产品图 Product drawing

产品名称 Item name	S01.01.01.302 MAXWELL-16-A50	产品材质 Product material	PC
图法 View	 第三视角	设计 Designaner	Yvan
比例 Share	1:1	审核 Checked	Haiqiu
单位 Unit	MM	批核 Approved	JG Wu

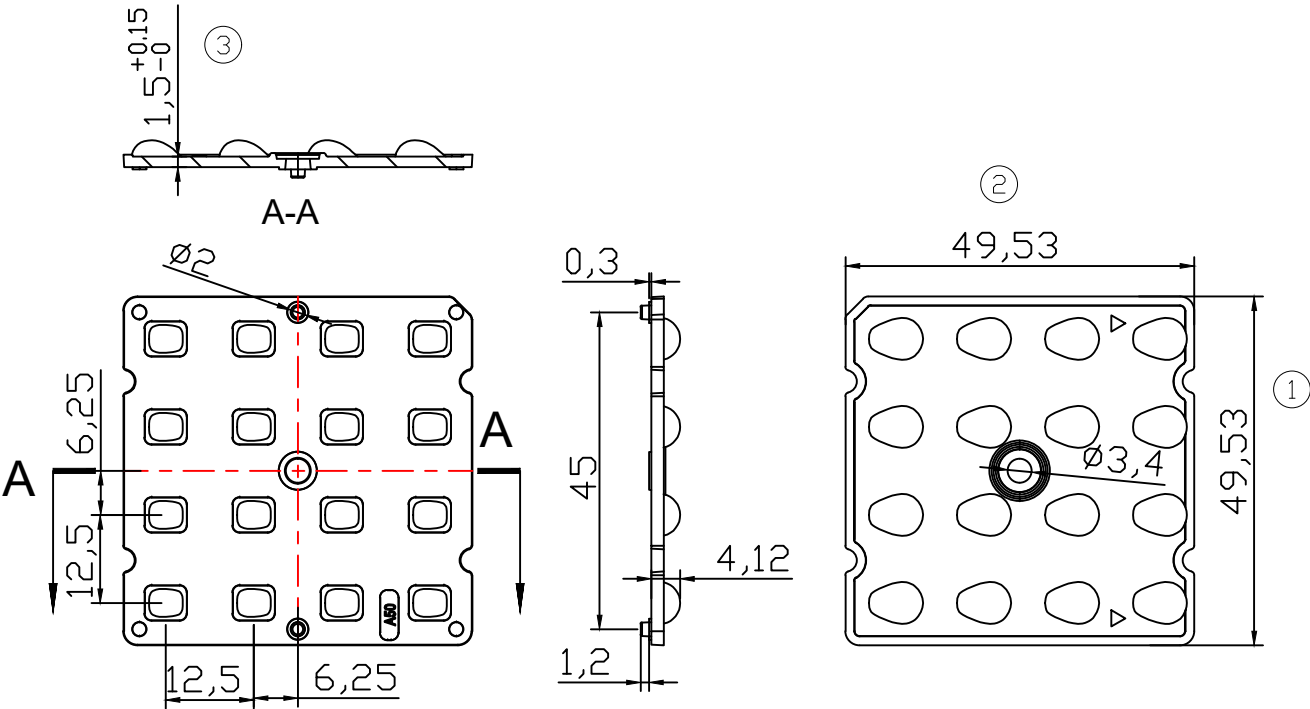
版本 REV	日期 DATE	变更内容 CHANGE (ITEM)
A0	2023-5-2	新建 NEW
A1	2023-12-28	③ 1.5±0.1改为1.5 ^{+0.15} ₀ 、名称加-G1
